November 1, 2022

ADDENDUM 2

Walnut Valley Unified School District
Diamond Bar High School
Building 400 Modernization New Classrooms/Library Media
DSA #03-121330 | File #19-H52

A10.31

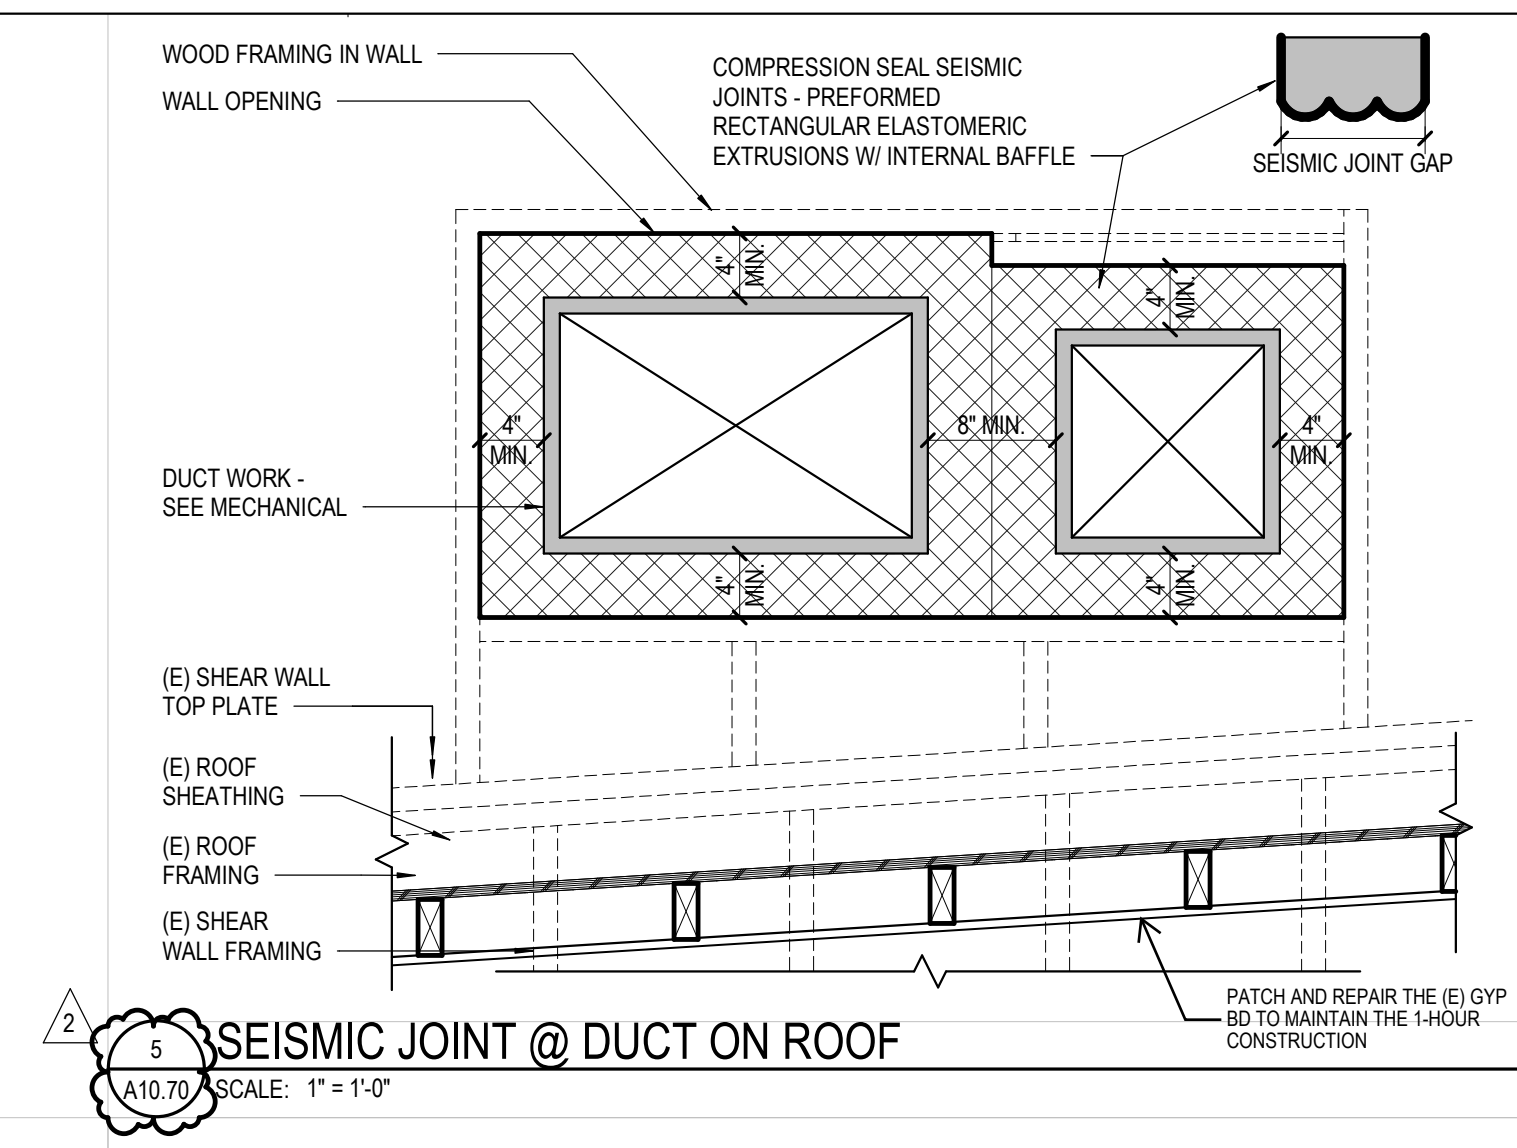
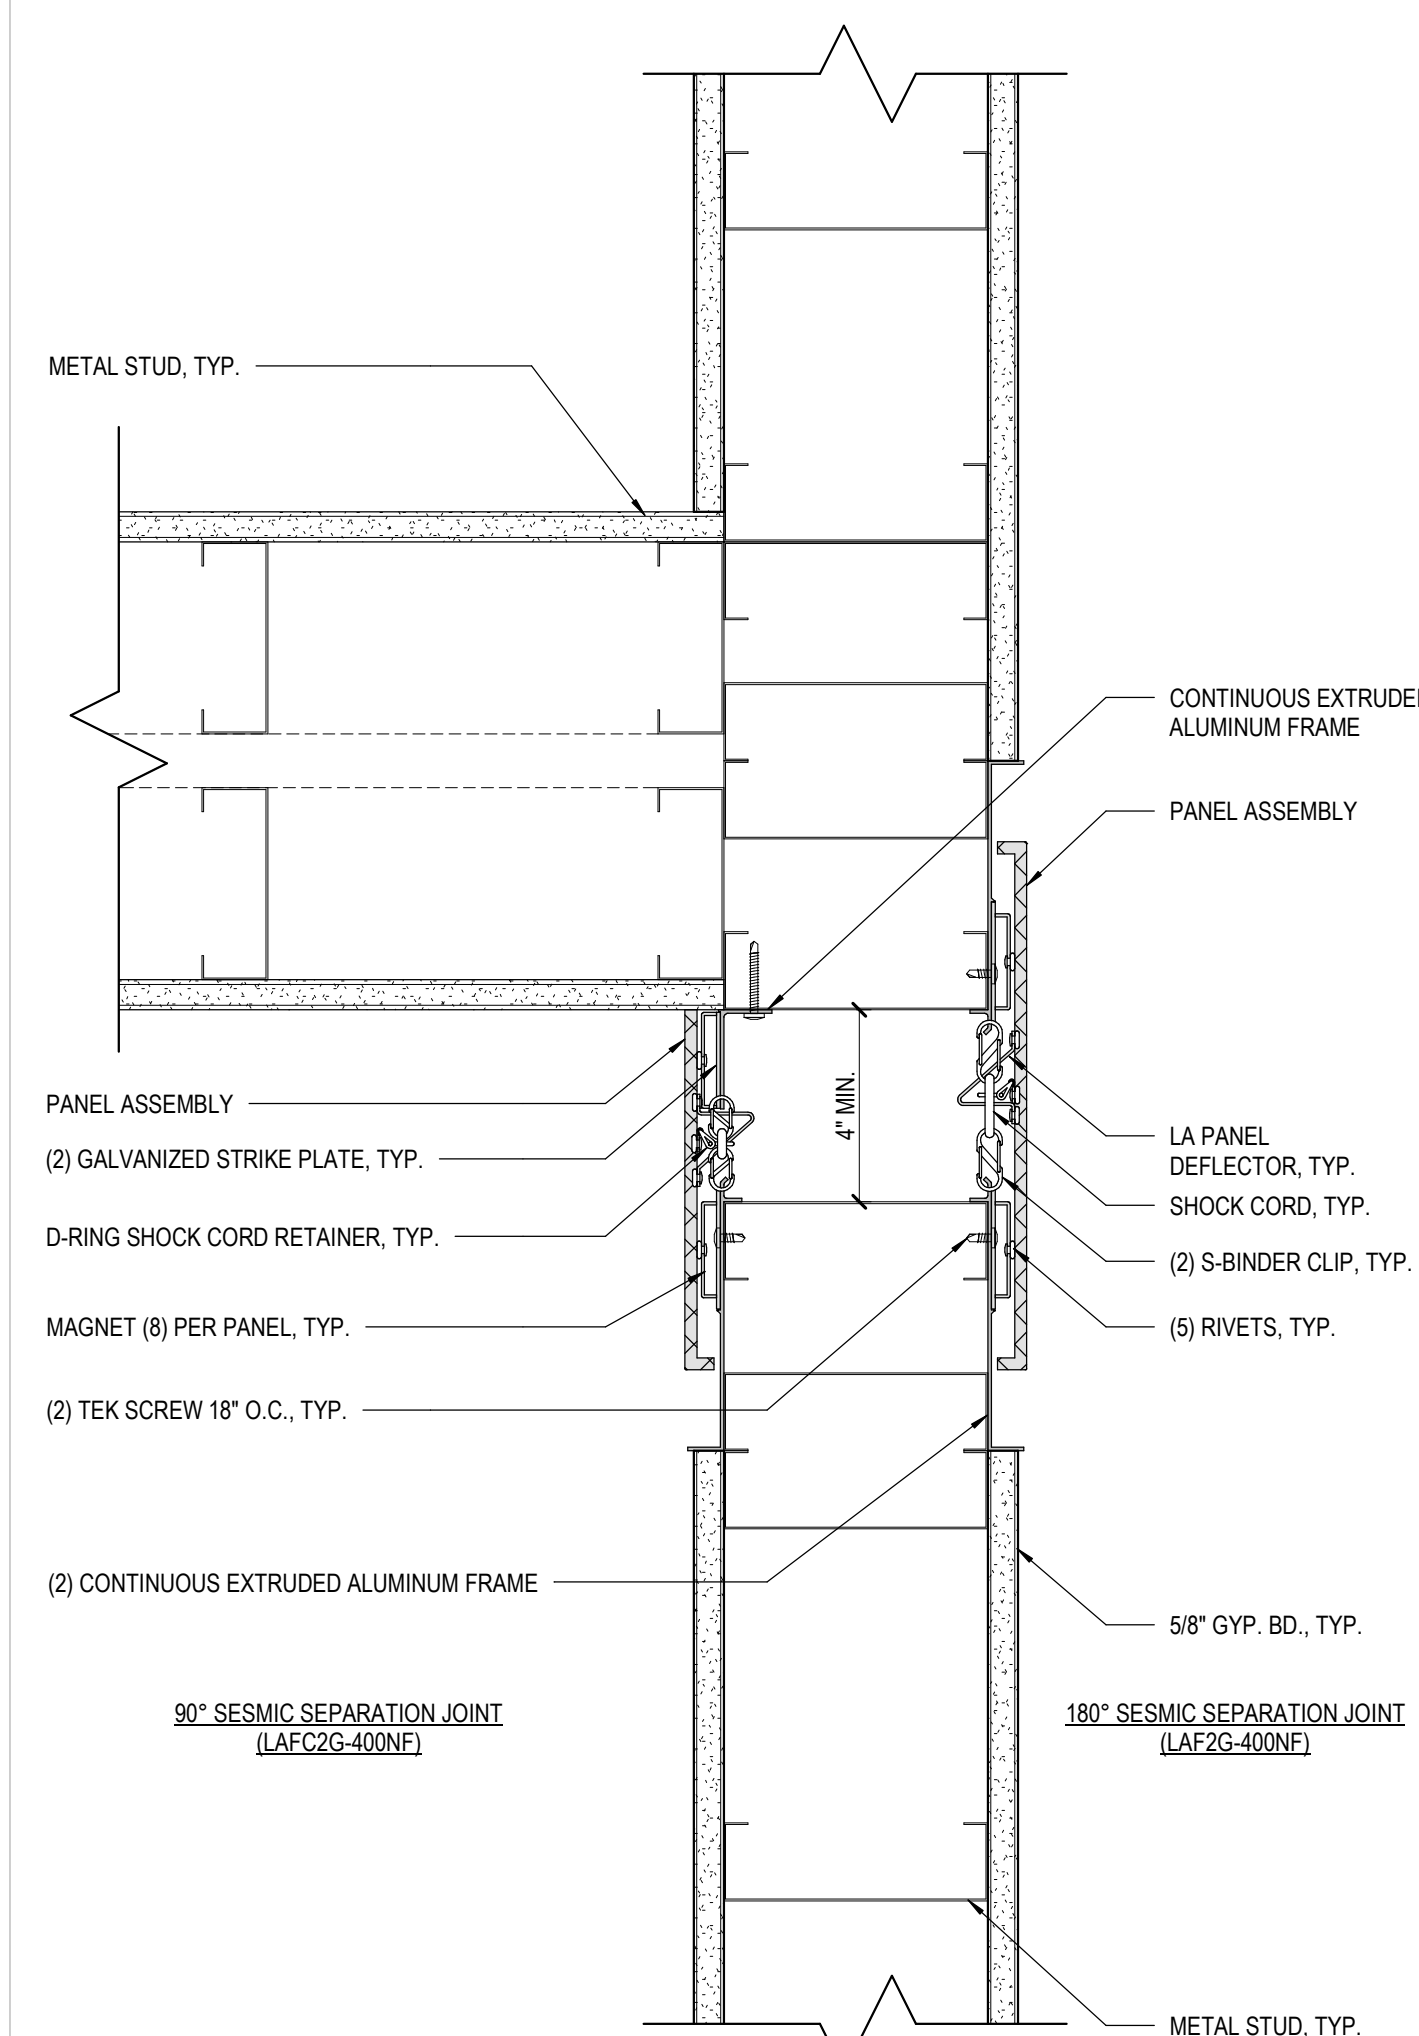
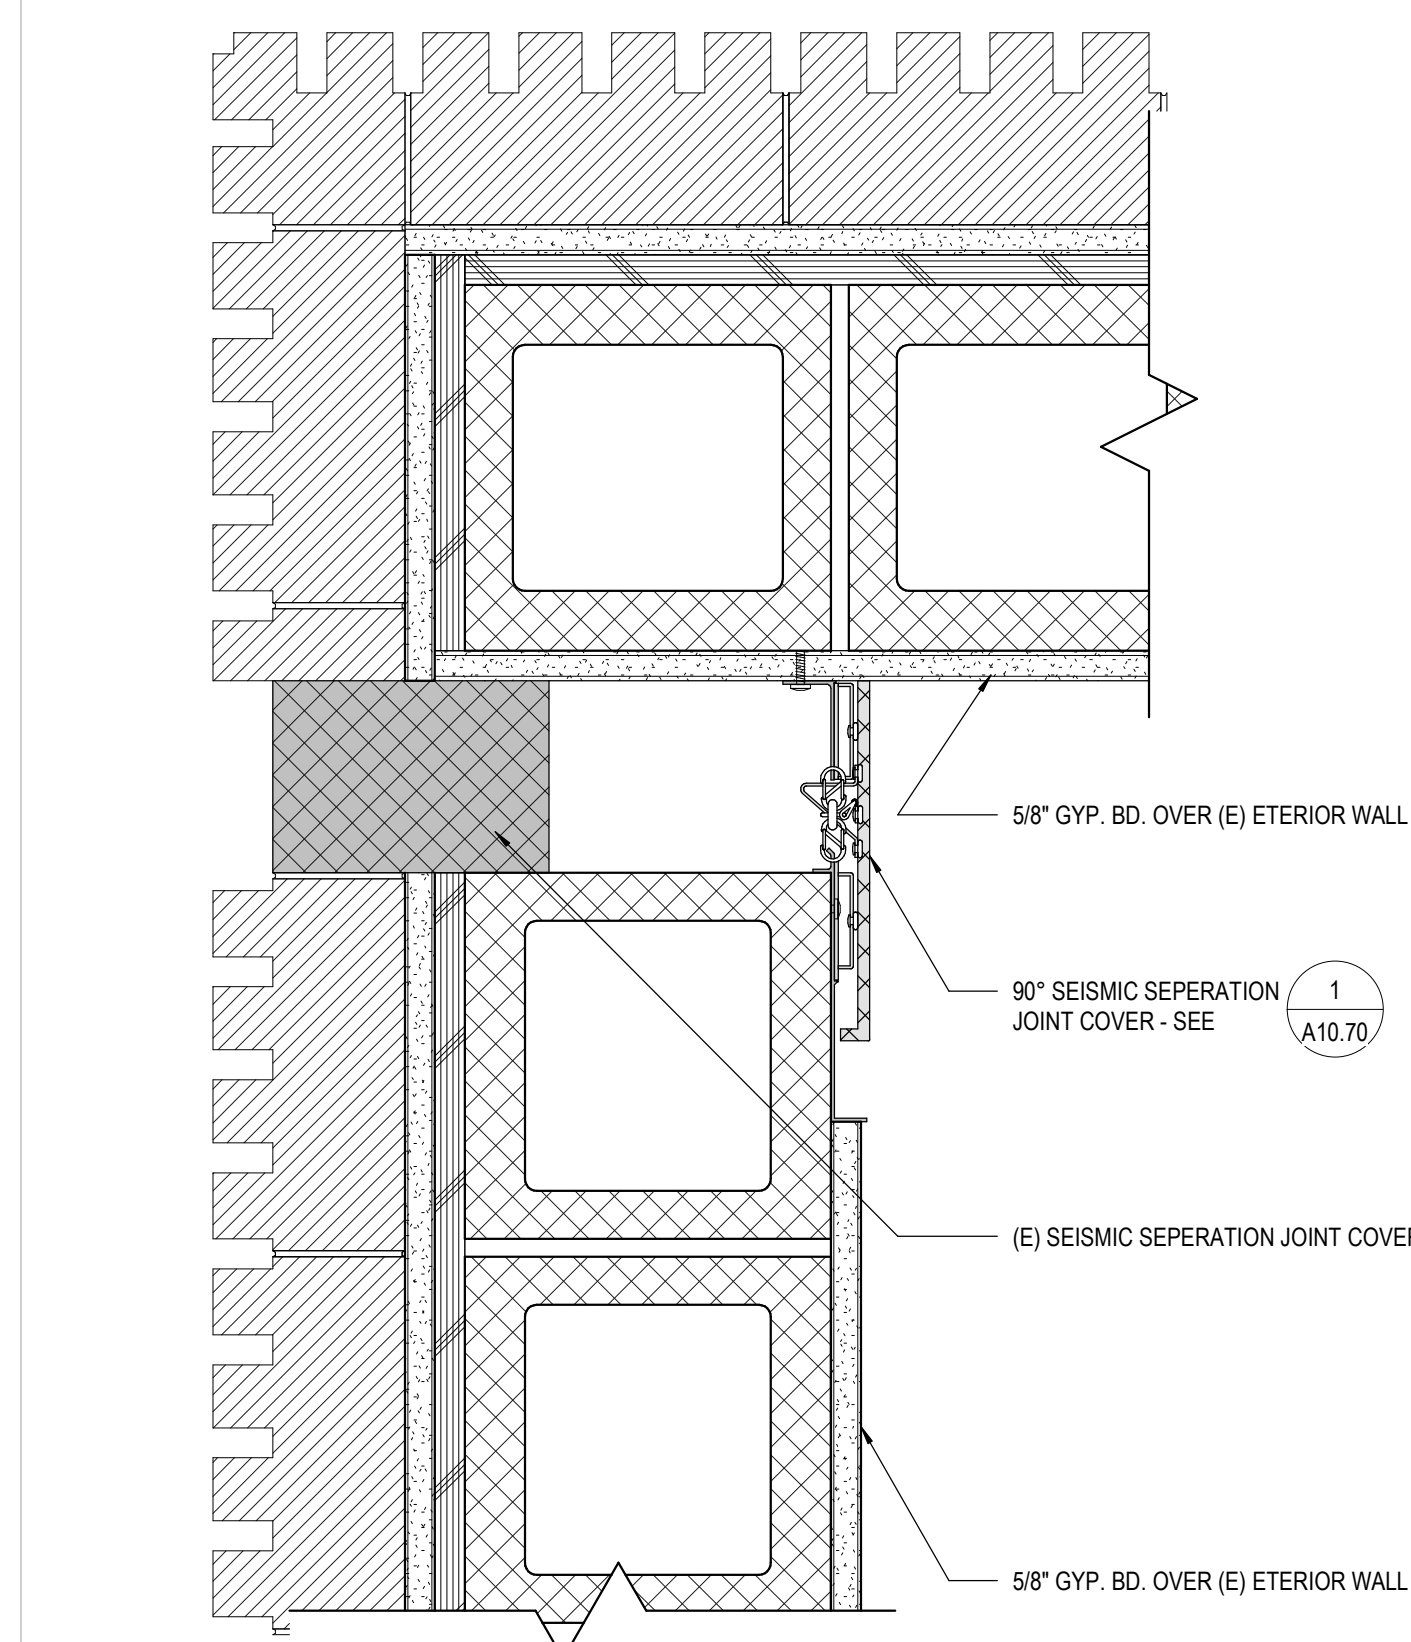
A10.31 CEILING DETAILS

- A. 5/A10.31: DELETED DETAIL. THE CORRECT DETAILS FOR THE SUSPENDED WALL AT THE SEISMIC JOINT ARE NOW DETAILS 3/A10.30, 8/A10.70, 13/A10.70 AND 18/A10.70 ISSUED IN ADDENDUM 1.
